NATIONAL FIRE PROTECTION ASSOCIATION

M E M O R A N D U M

SUBJECT: NEC® First Draft CMP FINAL Ballot Results (A2025)

[Figure 794.135\(D\) Cable Substitution Hierarchy.](#)

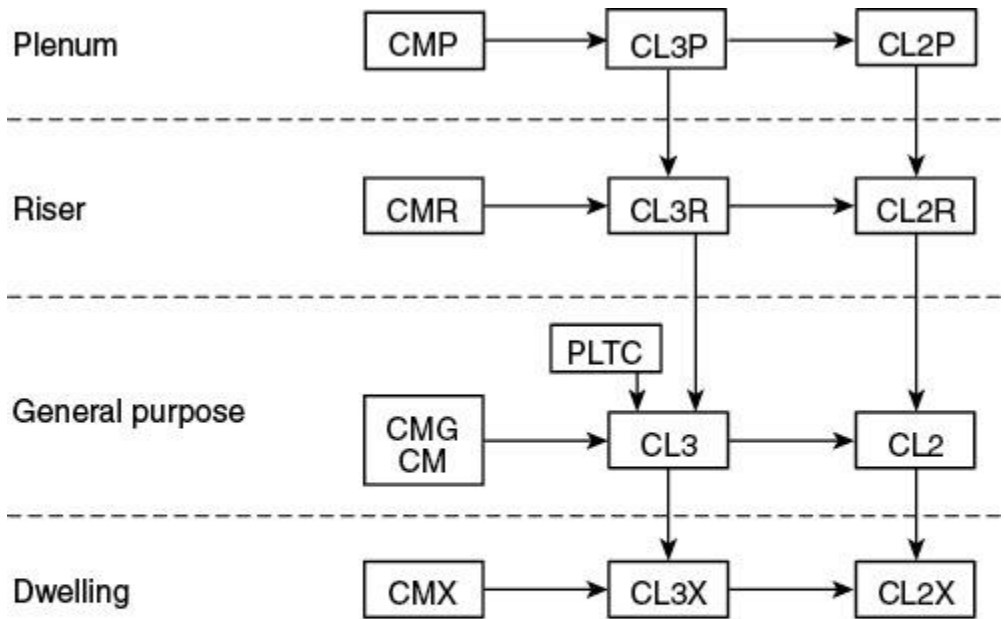
[\[Figure 725.154\(A\) from the 2020 edition of NFPA 70, inserted by FR 8379\]](#)

The substitutions for cables listed in Table [722.135\(E\)/794.135\(D\)](#) and illustrated in Figure [794.135\(D\)](#) shall be permitted. Where substitute cables are installed, the installation requirements of the articles described in [722.3\(O\)/794.4\(K\)](#) shall also apply. CI cables shall be permitted to be installed to provide 2-hour circuit integrity. See [722.135\(F\)/794.135\(E\)](#).

Figure Informational Note Figure 792.30(B) Class 2 and Class 3 Circuits.

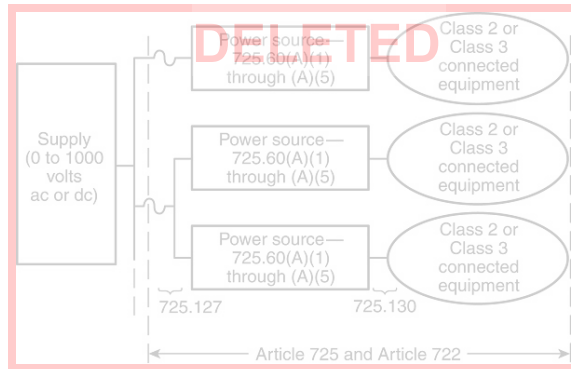
The Informational Note Figure is moved from 725.60(B) to 725.60(A) where it is referenced in Informational Note No. 1.
